City of Ontario

ADDENDUM NO. 8 Bid Invitation # 1900

TODAY'S DATE:	Monday, April 14, 2025
PROJECT TITLE:	D&C23-022 Ontario Sports Empire
BID PACKAGE:	D&C23-022 Ontario Sports Empire (BC03 & BC18)
BID CLOSING DATE:	April 17, 2025 at 2 p.m. No Change
CITY RESPONSE:	April 10, 2025 No Change
Q & A DEADLINE:	March 27, 2025 at 5 p.m. No Change
PRE-BID WALK:	March 12, 2025 at 8 a.m.

Project: Ontario Sports Empire

SCALE	1
1"=1'-0"

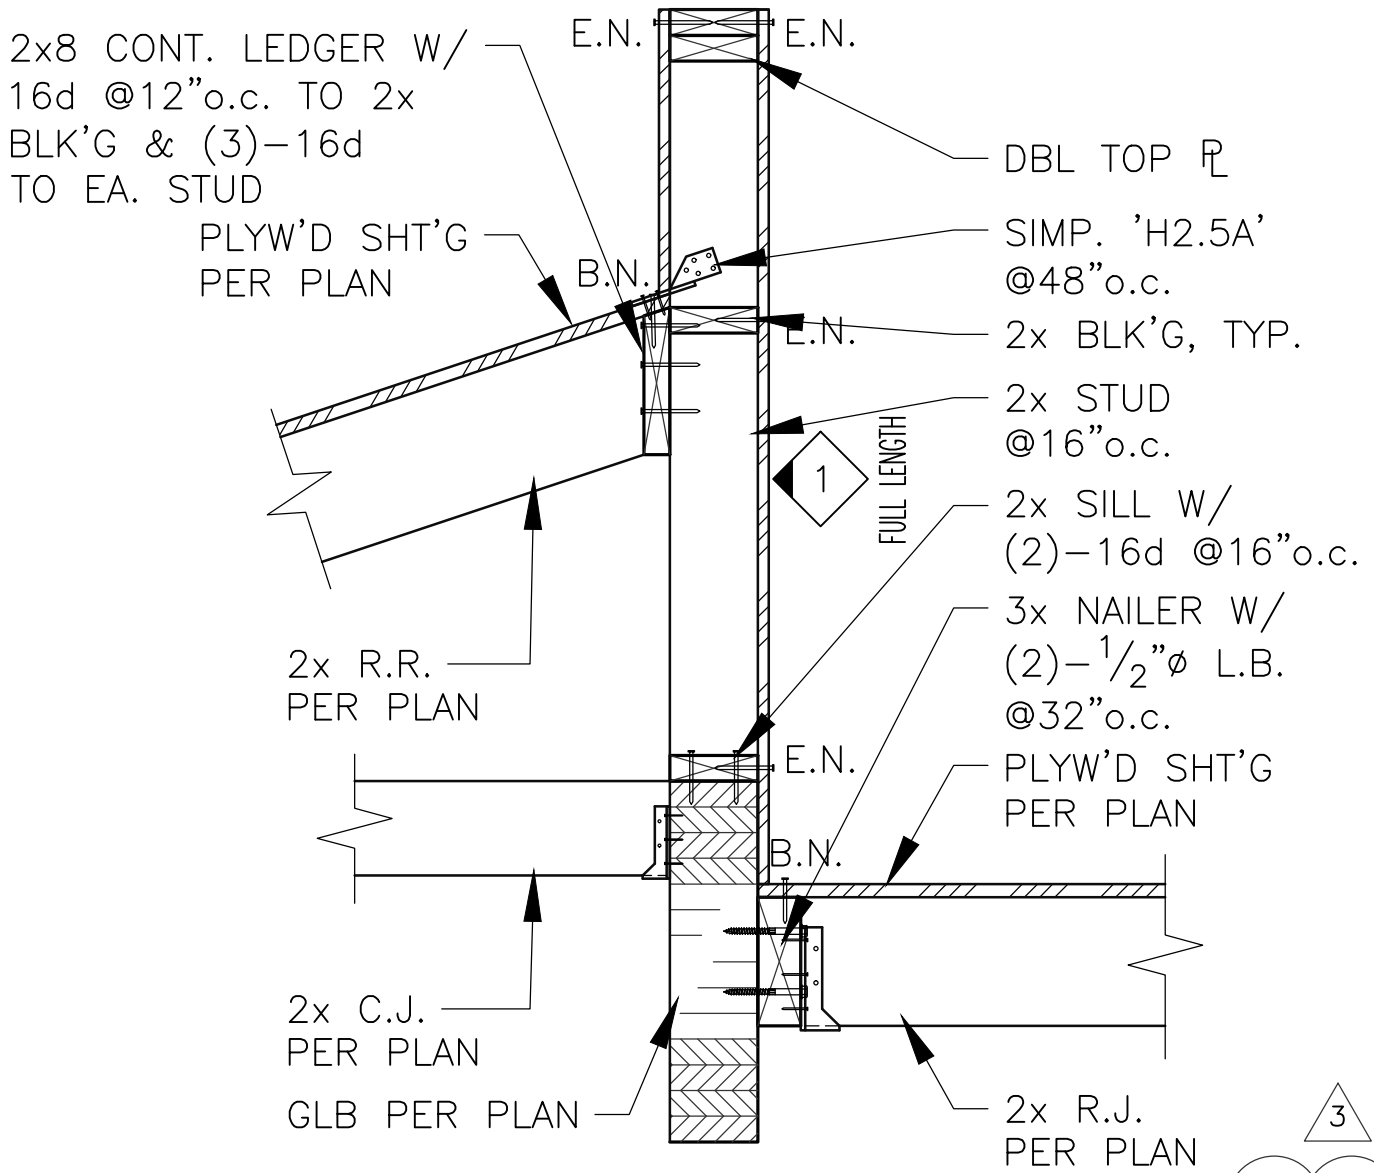
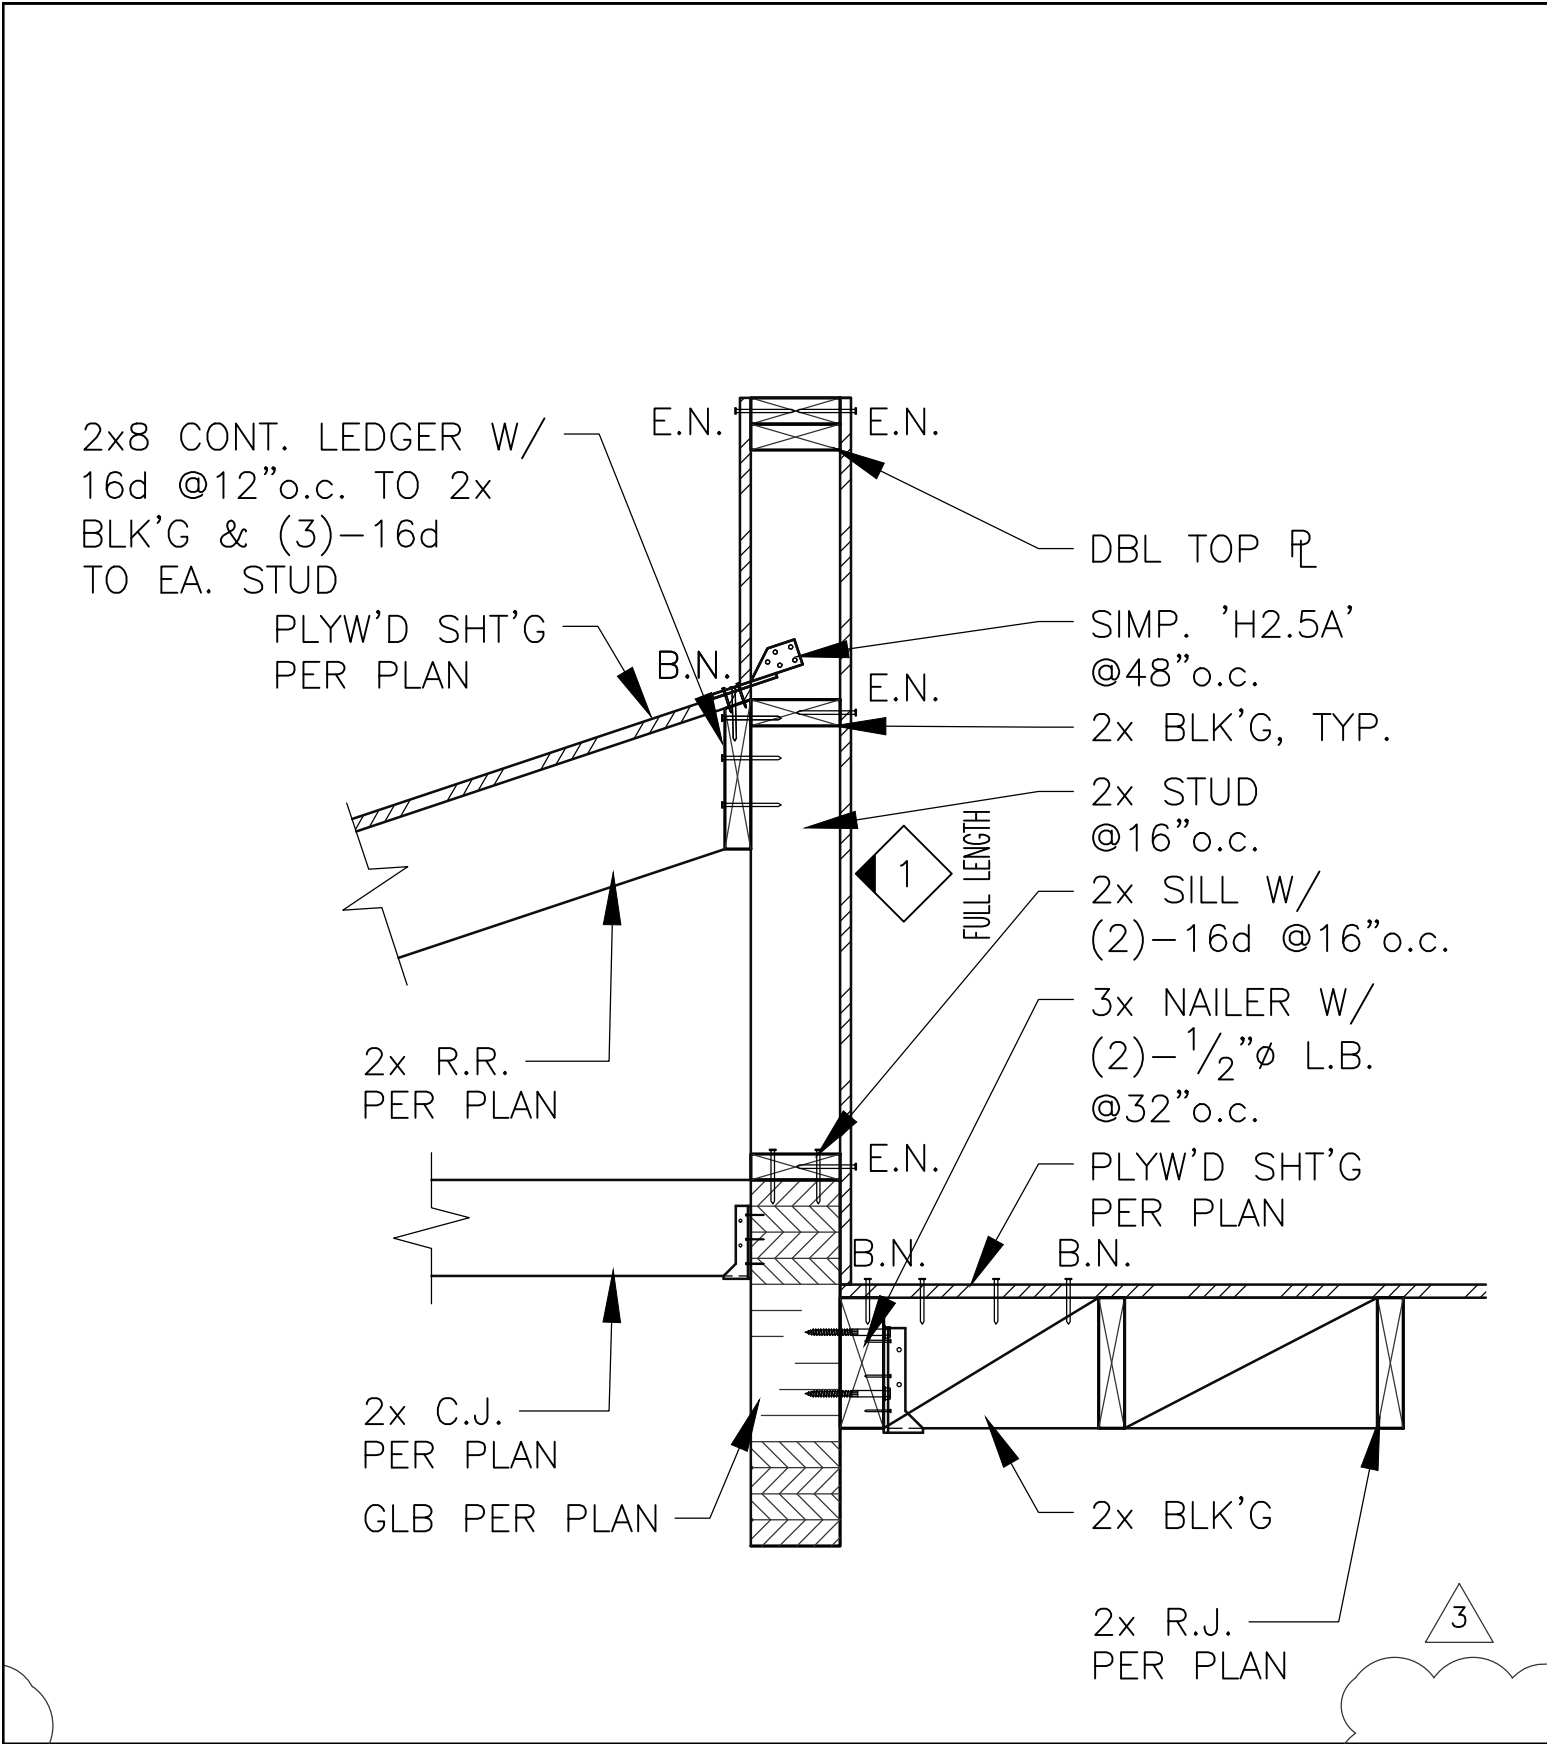
g247, Green Room/IT Building Mechanical Well Parapet, Details 1 & 2/S8.1 do not match the design shown on sections 1 & 2/A-8.4 & 13/A-9.7. The vertical 2x6 wall extends 2'-0" + above the sloping roof with plywood on both sides & a 3 or 4x nailer on top. Assuming that arch'l is correct please revise the details.

PLEASE SEE ATTACHED 1 & 2/S8.1.

12

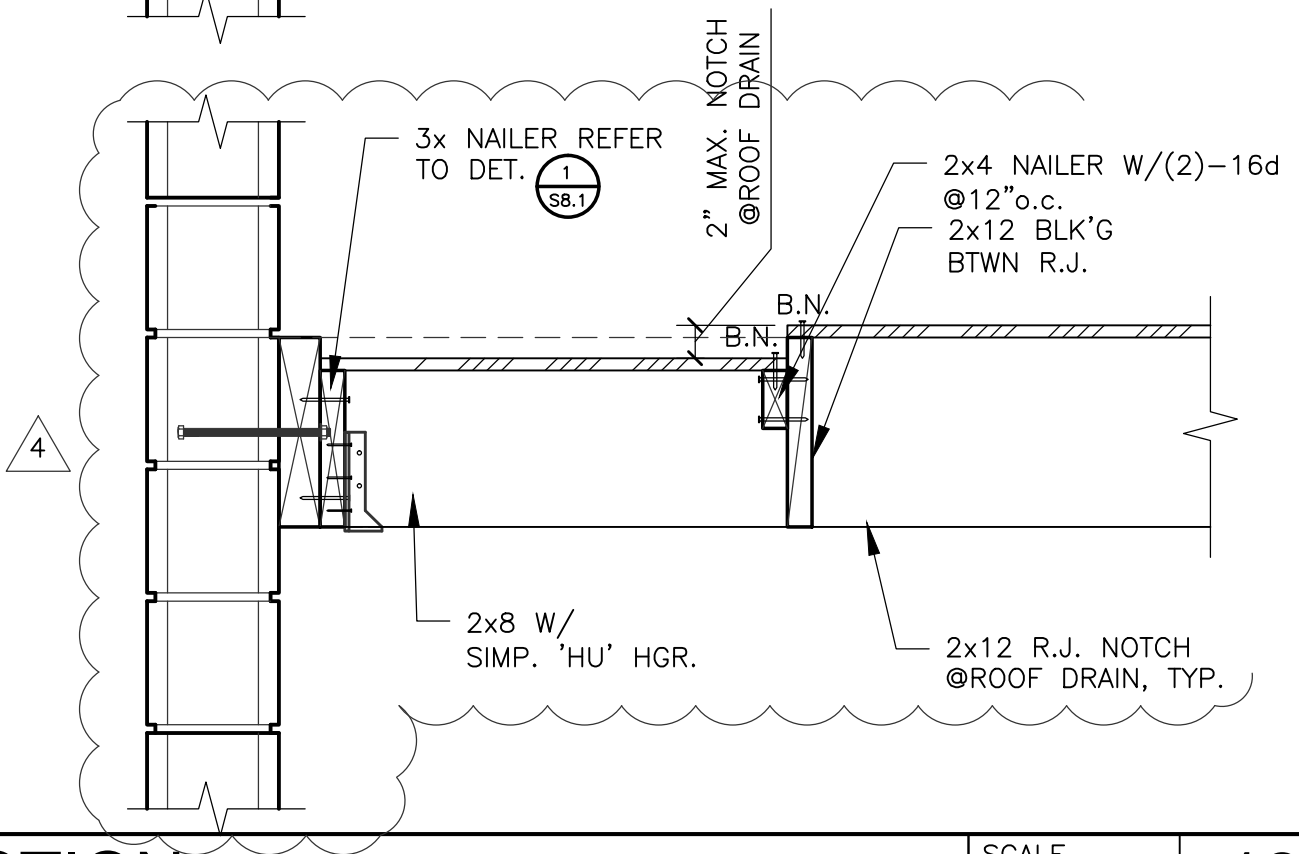
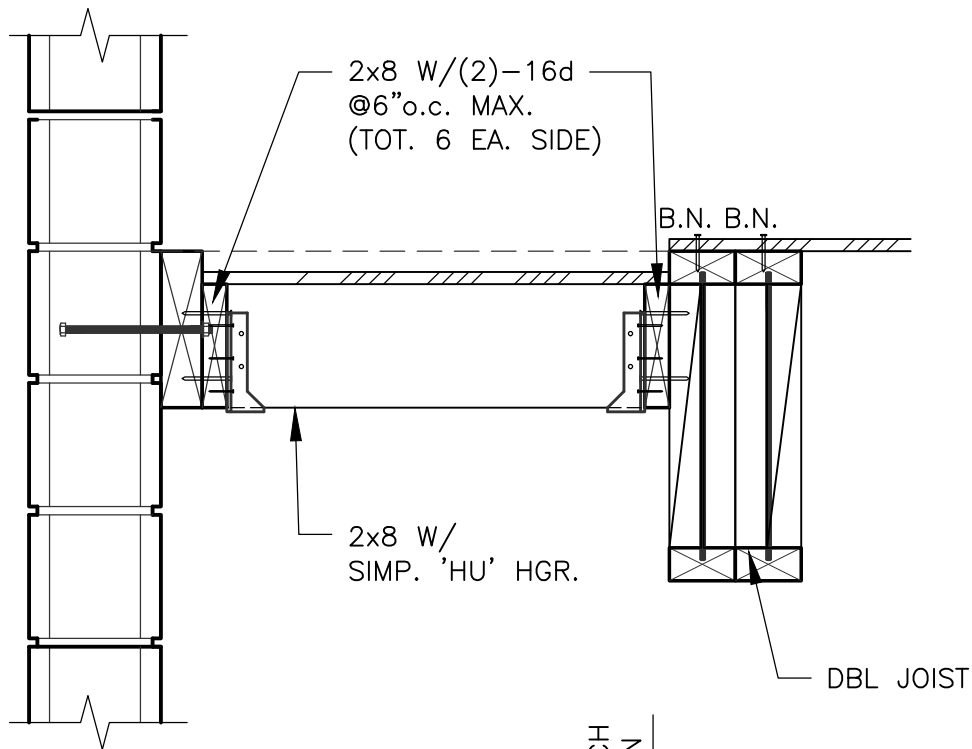
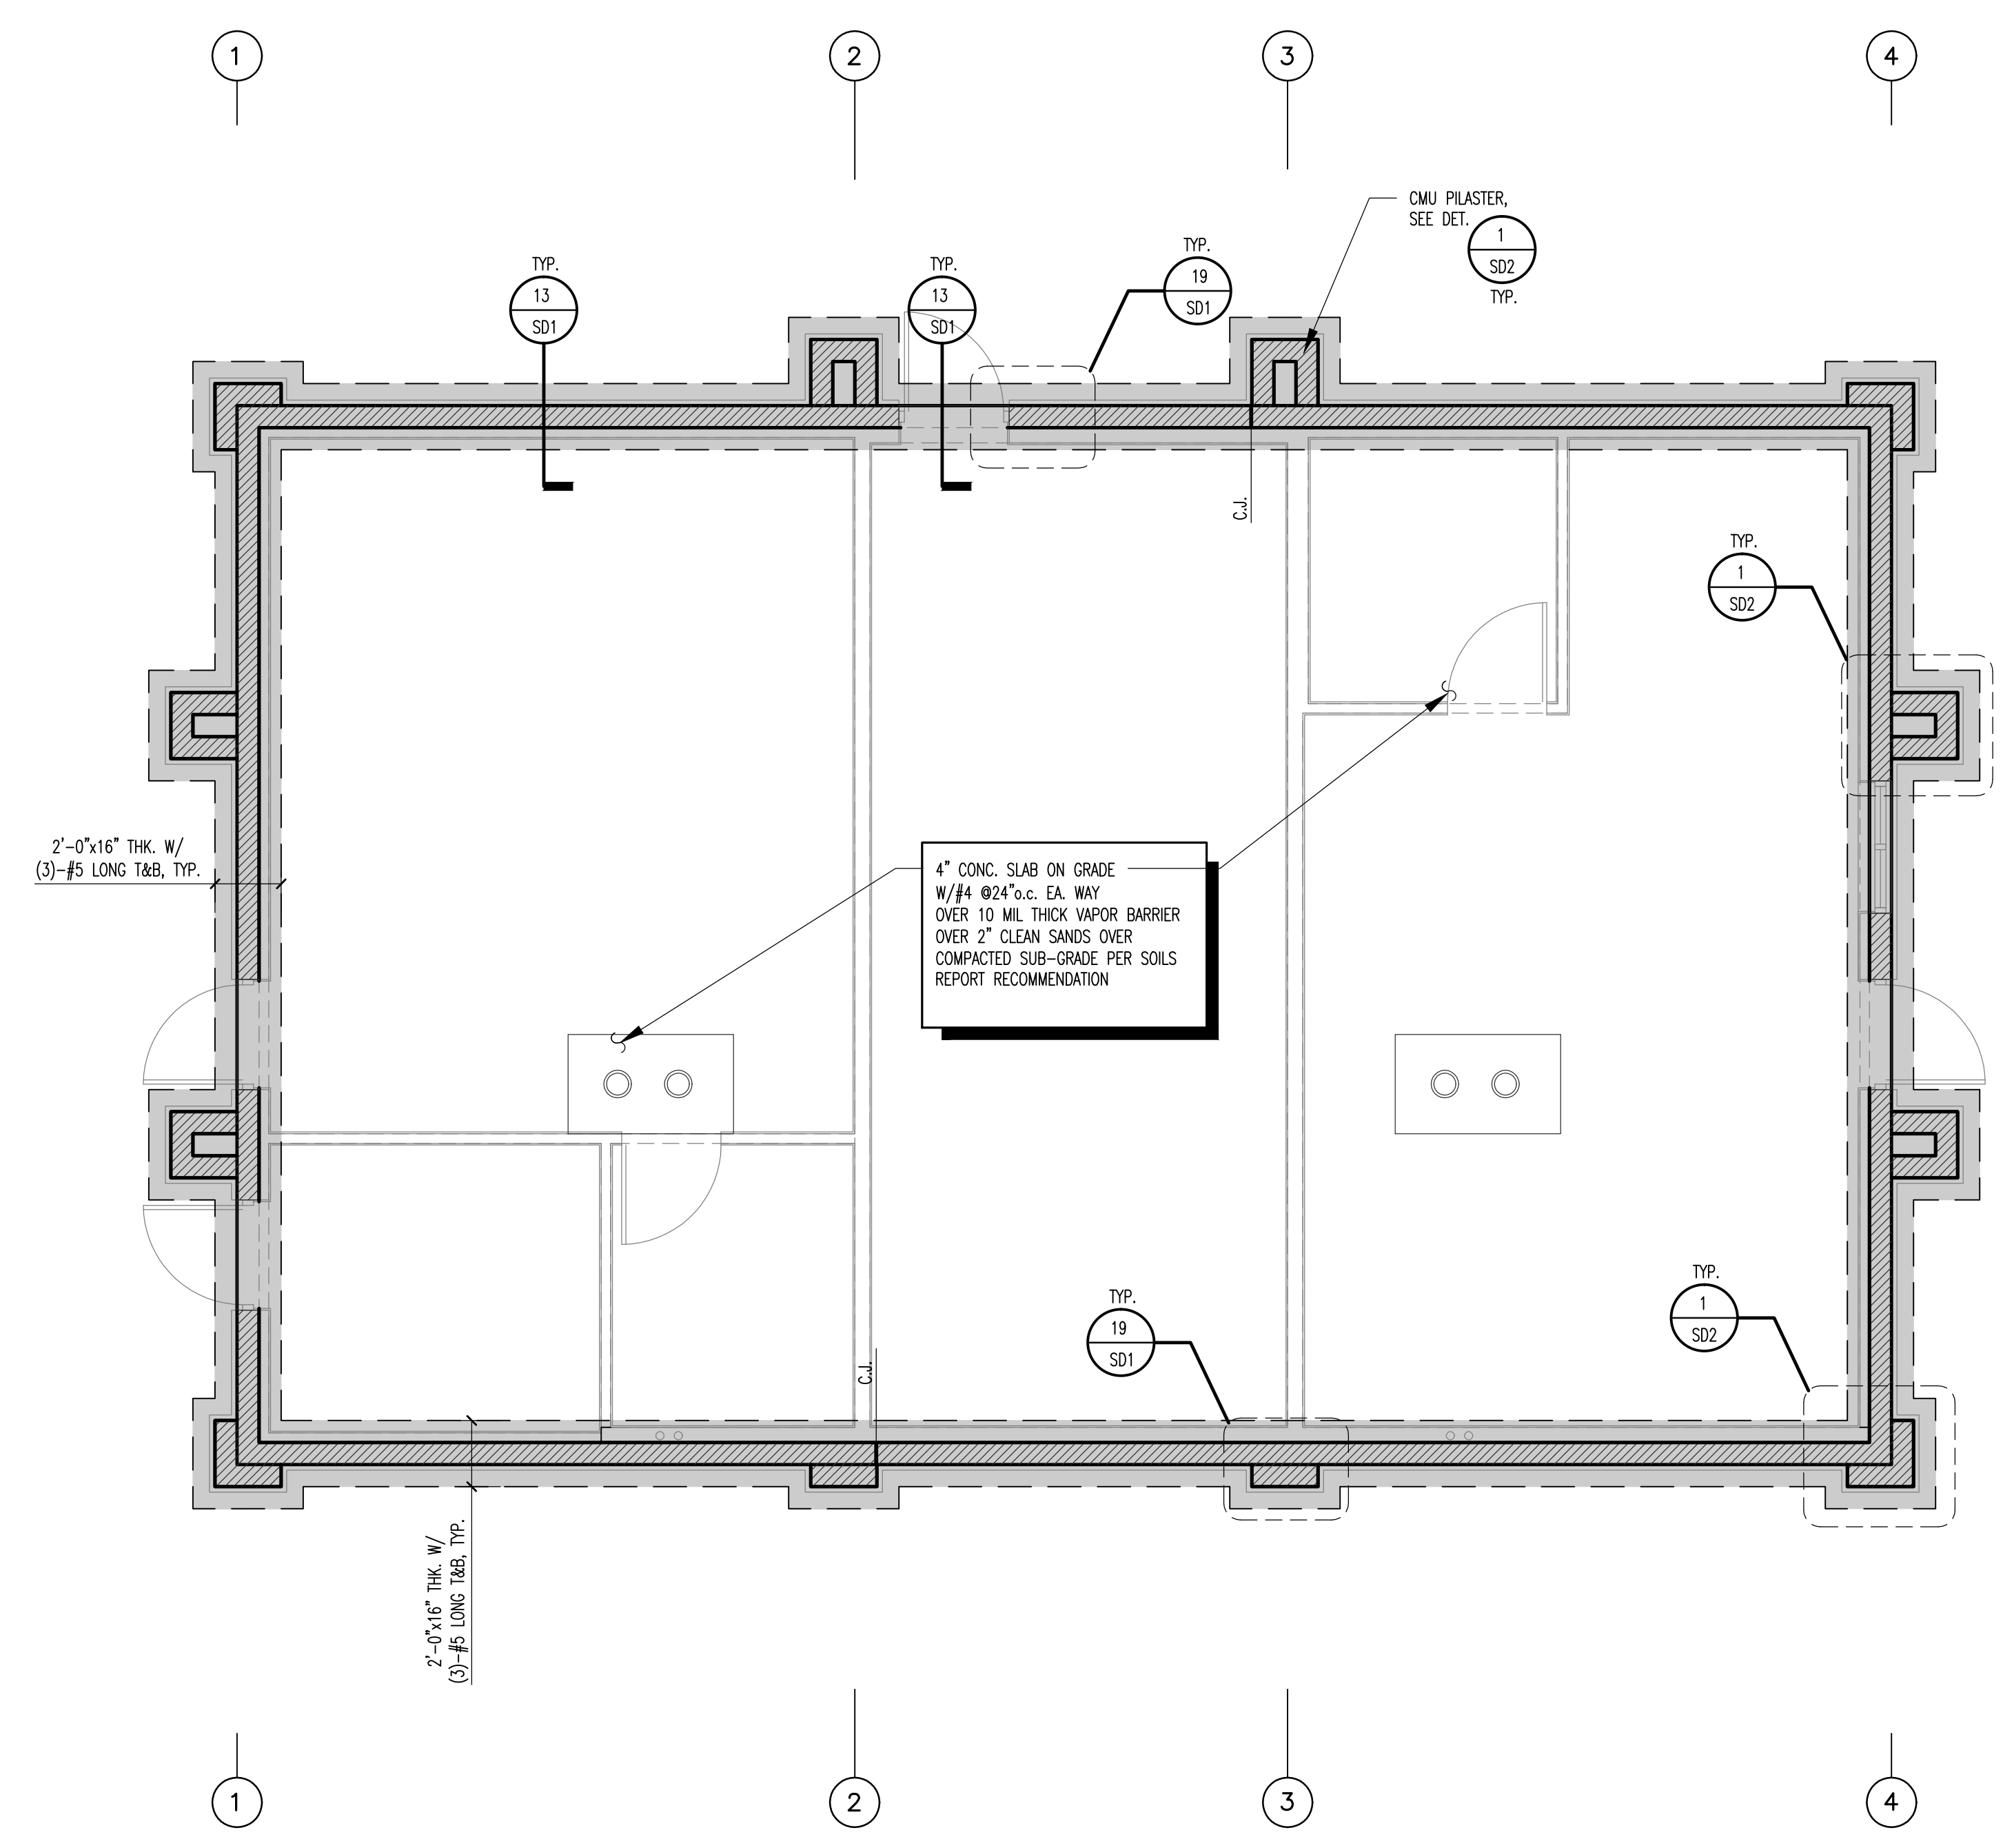
Green Room Building Mechanical Well, a) Where DBL joist are noted provide the size. b) Please note the locations for the roof & overflow drains. Would detail 12/S1.5 apply for the framing? Reference S8.1

A. USE DBL 2x6 CJ @16"o.c. NOTED PER PLAN.
B. ROOF & OVERFLOW DRAINS PER ARCHITECTURAL DRAWINGS ADDED ON S8.1. SIMILAR TO 12/S1.5. REFER TO ATTACHED DETAIL.
